**Consideration of draft amendments to existing UN Regulations
submitted by GRSP**

Proposal for Supplement 4 to the 08 series of amendment to UN Regulation No. 16 (Safety-belts)

Submitted by the Working Party on Passive Safety *

"Figure 10
3D view of the i-Size support leg installation assessment volume for assessing compatibility of the i-Size seating positions with support legs of i-Size child restraint systems

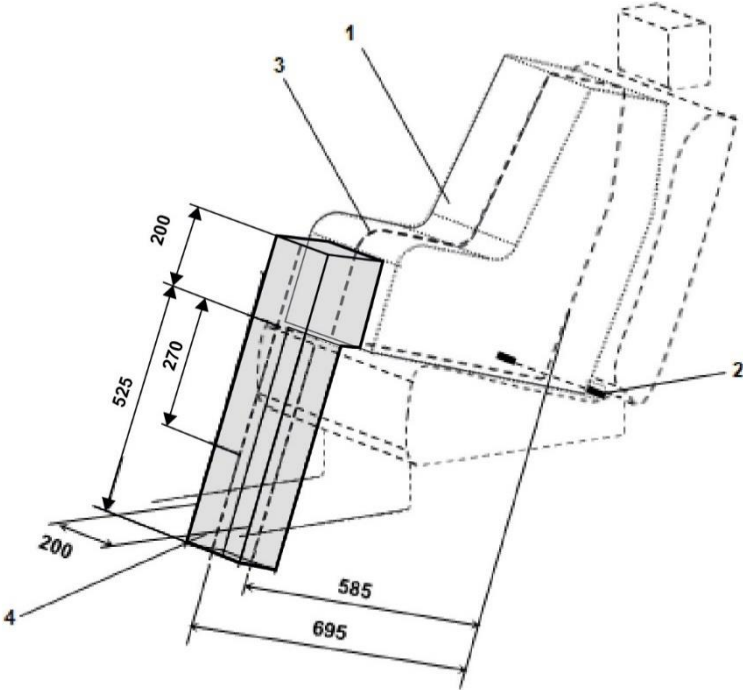
Annex 17, Appendix 2, Figure 10, amend to read:

- Key:
- 1. Child Restraint Fixture (CRF).
 - 2. ISOFIX low anchorages bar.
 - 3. Median longitudinal plane of the CRF.
 - 4. i-Size support leg installation assessment volume.
- Note: Drawing not to scale."

ISO/B2: Envelope dimensions for booster seat, reduced width 440 mm - without ISOFIX, or with connectors removed or stowed within the body of the fixture (behind line E, as defined by detail B)

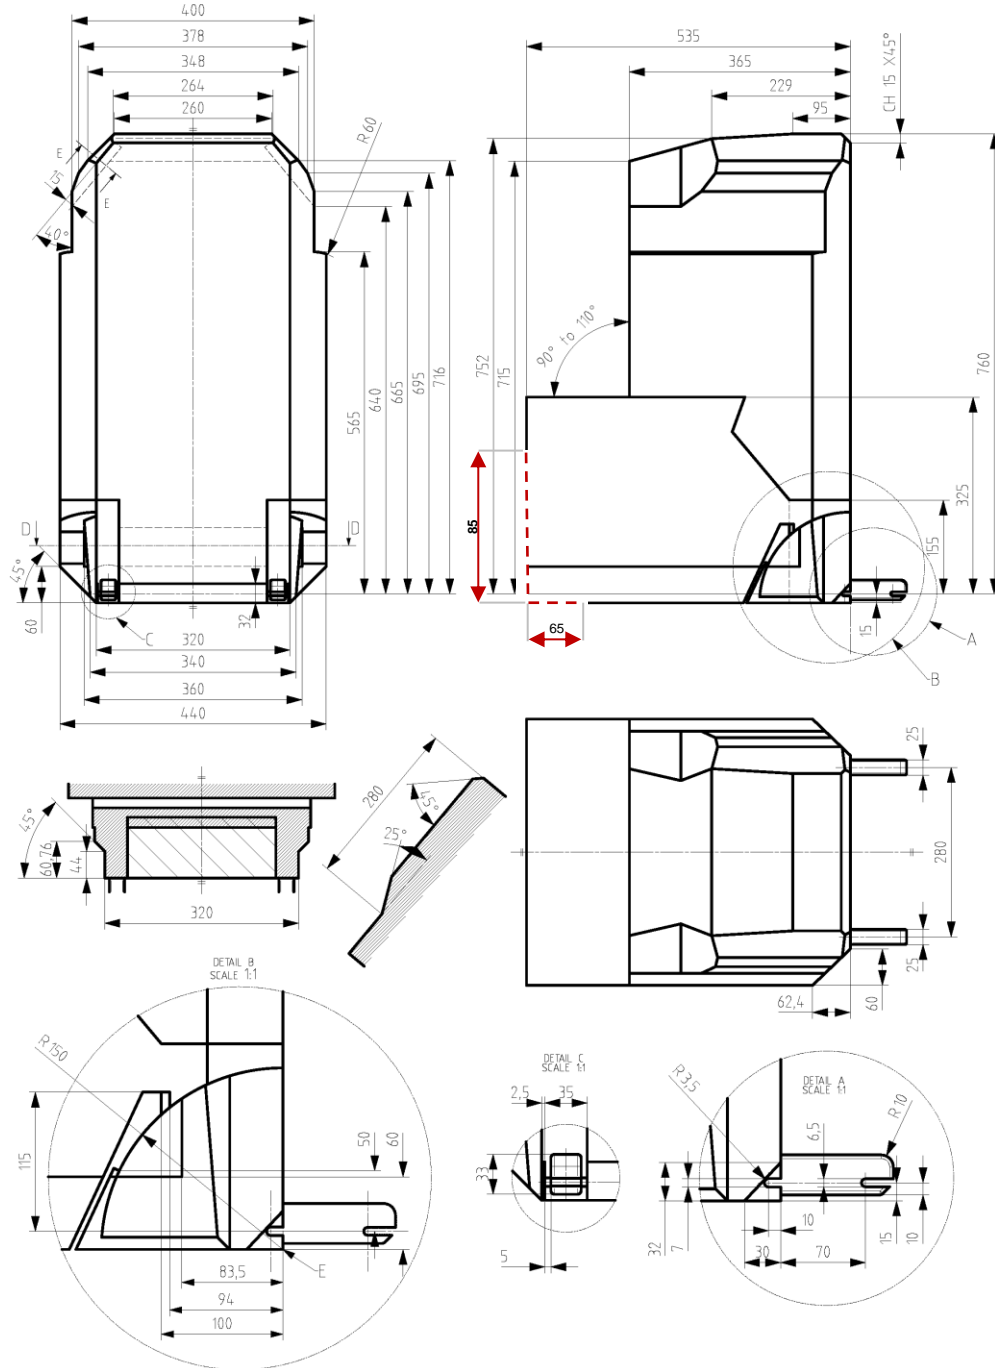
Annex 17 – Appendix 5, Figure 2, amend to read:

1. E is the Reference axle of rotation of the backrest (90° to 110°) and reference line for retraction/stowing of ISOFIX
2. Dashed lines mark the area where an anti-rotation device, or similar is allowed to protrude"

"Figure 3
ISO/B3 - Envelope dimensions for booster seat, full width 520 mm - without ISOFIX, or with connectors removed or stowed within the body of the fixture (behind line E, as defined by detail B)

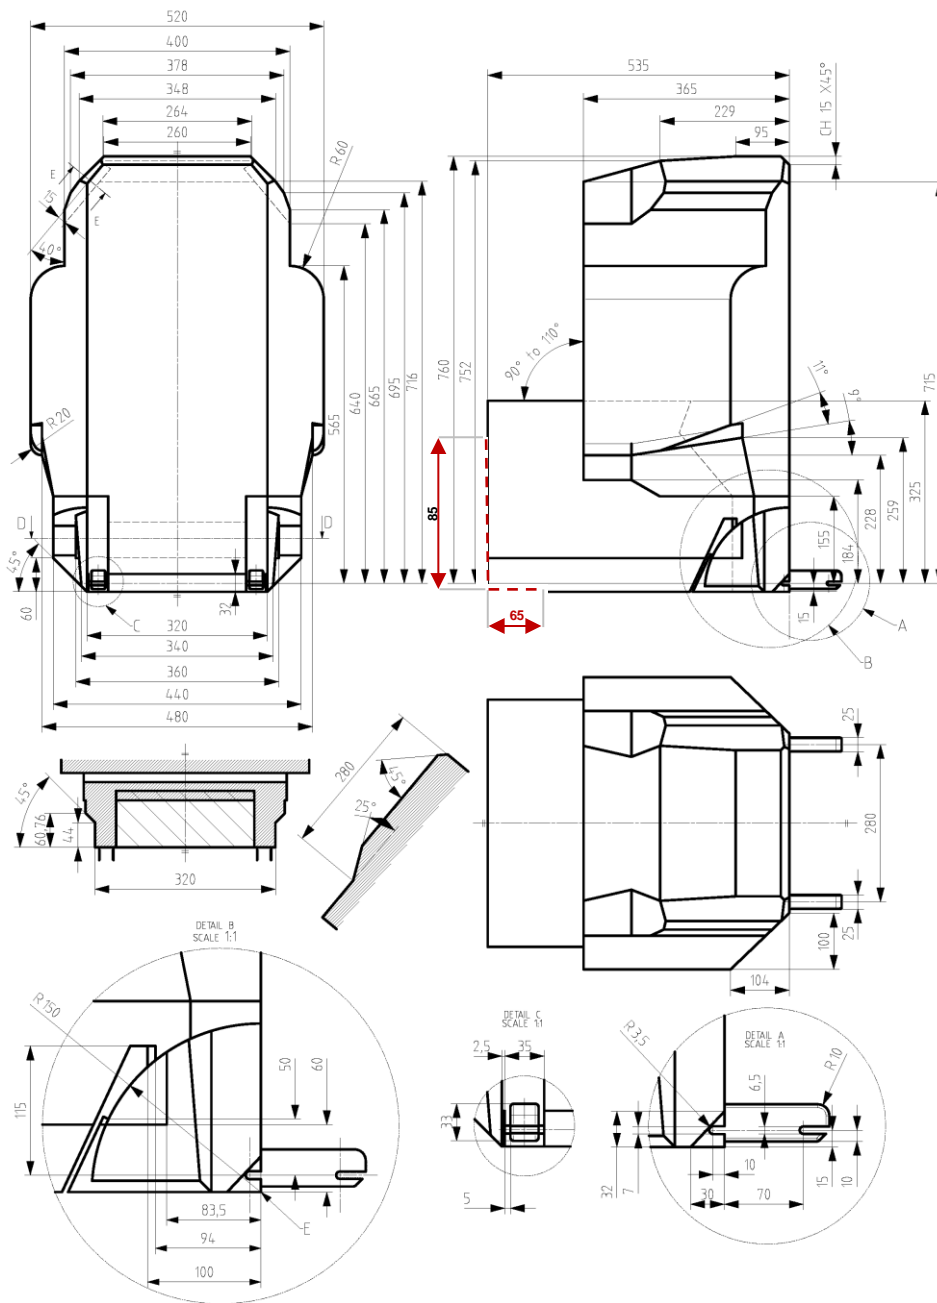
Annex 17 – Appendix 5, Figure 3, amend to read:

1. E is the reference axle of rotation of the backrest (90° to 110°) and reference line for retraction/stowing of ISOFIX
2. Dashed lines mark the area where an anti-rotation device, or similar is allowed to protrude"
